SIM 34 01 24

RECALL 24V-104: INTEGRATED BRAKING SYSTEM (IB)

This Service Information Bulletin (Revision 12) replaces SI M34 01 24 **dated May 2025**.

- Correction updated with new part numbers
- Parts Information updated

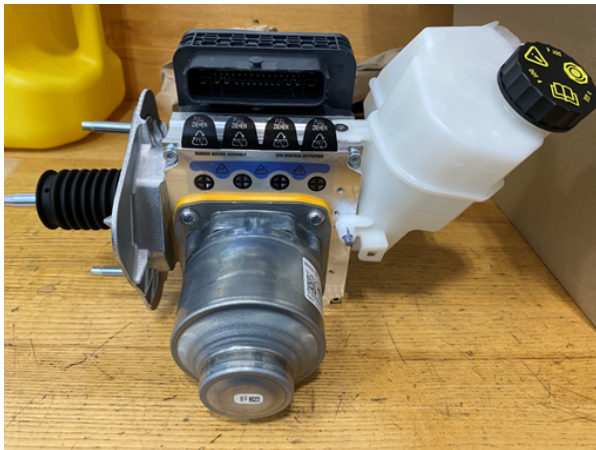
Replace the IB with either a “wet” pre-filled unit or a “dry” unfilled unit.

“Wet” IB pre-filled: Brake fluid reservoir is filled (arrow) and brake fluid line ports are plugged with bolts (circled)

“Dry” IB unfilled: Brake fluid reservoir is empty; brake fluid line ports are sealed with labels.

5B67B85
5B72715
5B72716
5B6A736

Part numbers:
5B3C874
5B6C7F1

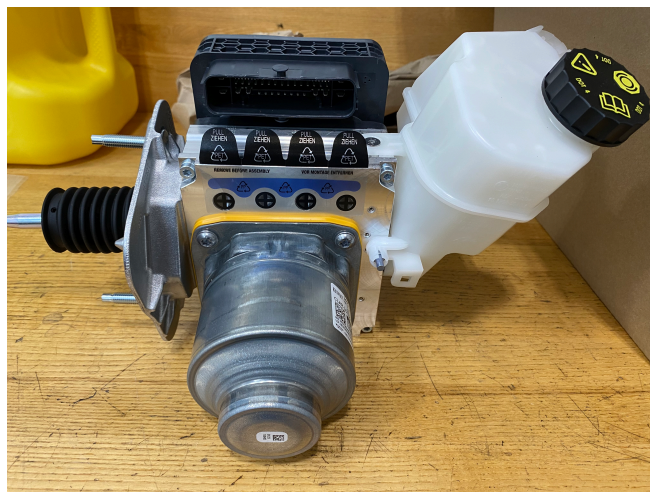
Replace the IB with either a “wet” pre-filled unit or a “dry” unfilled unit.

“Wet” IB pre-filled: Brake fluid reservoir is filled (arrow) and brake fluid line ports are plugged with bolts (circled).

“Dry” IB unfilled: Brake fluid reservoir is empty; brake fluid line ports are sealed with labels.

5B67B85
5B6E463
5B6E465
5B6E467
5B69D61
5B69D63
5B69D65
5B72715
5B72716
5B6F947
5B6F943

5B3C874
5B3C857
5B421D0
5B3C859
5B6C7F1
5B6C7F2
5B6C7F3
5B6C7F5
5B6A736
